DEVELOPMENT ASSESSMENT REPORT
Shire of Augusta Margaret River
19 October to 25 October 2023

DEVELOPMENT APPLICATION ASSESSMENT
Report to Manager Planning and Regulatory Services

Proposed Holiday House
48 (Lot 892) Wilderness Road Margaret River

Proposed Single Dwelling
6A (Lot 103) Brady St Augusta

Figure 1: Existing Building envelopes (white dashed line) 3,587m², and 678m². Proposed building envelopes (yellow solid line) 1,500m² and 500m².

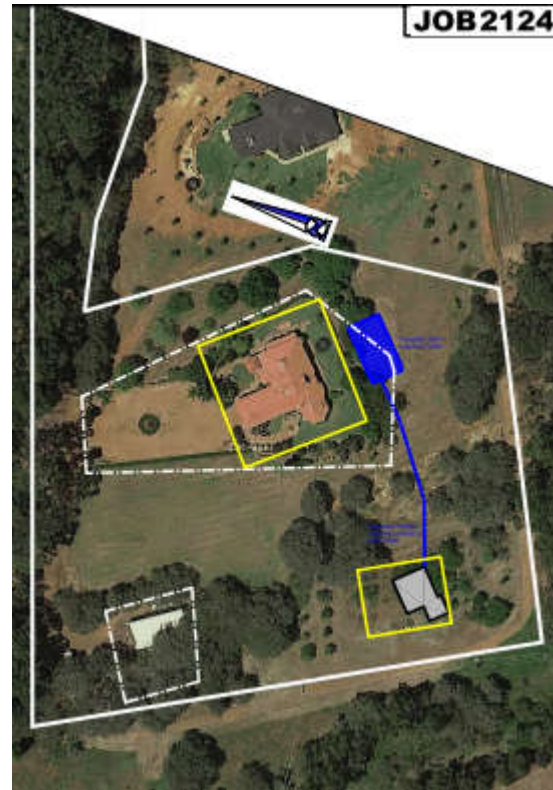
The split envelope approach is extremely site specific and seeks to rectify a legacy issue of two building envelopes allocated to the site of a size that we would not normally support. See figure 1 for existing and proposed building envelope plan.

- The proposed second building envelope presents a rear (southern) setback of 26m in lieu of 30m – variation to Schedule 9 of Local Planning Scheme No. 1.
- Proposed development outside of the building envelope (existing shed and water tank).

5. The revised building envelope plan hereby approved, wholly replaces that previously applicable to the site.
6. Clearing of vegetation is prohibited outside the building envelope, unless in accordance with the *Bush Fires Act 1954* or required for the purpose of constructing an approved driveway, installing essential services, or removing dead or dangerous trees as verified by a suitably qualified arboriculturist.
